Technical Service Bulletin

94 Moisture accumulation in headlamps

94 12 91 2028277/3 October 24, 2012. Supersedes Technical Service Bulletin Group 94 number 12-68 dated March 1, 2012 for reasons listed below.

Model(s)	Year	VIN Range	Vehicle-Specific Equipment
Q7	2010-2011	000001-999999	Not Applicable
	2012	000001-004736

Figure 2. Ventilation Hose with Integrated Filter

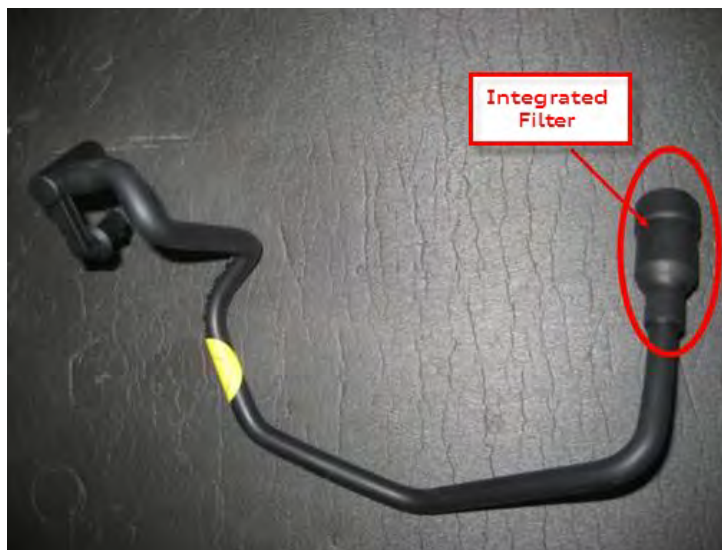
2. Replace the headlamp ventilation hose for each headlamp with the new part number to help reduce any further humidity ingress into the headlamps (see Part information table below).

The modified ventilation hose can be recognized by the integrated filter as seen in Figure 2.

Part Number	Part Description	Quantity
4L0941717A	Left Headlamp Ventilation Hose	1
4L0941718A	Right Headlamp Ventilation Hose	1
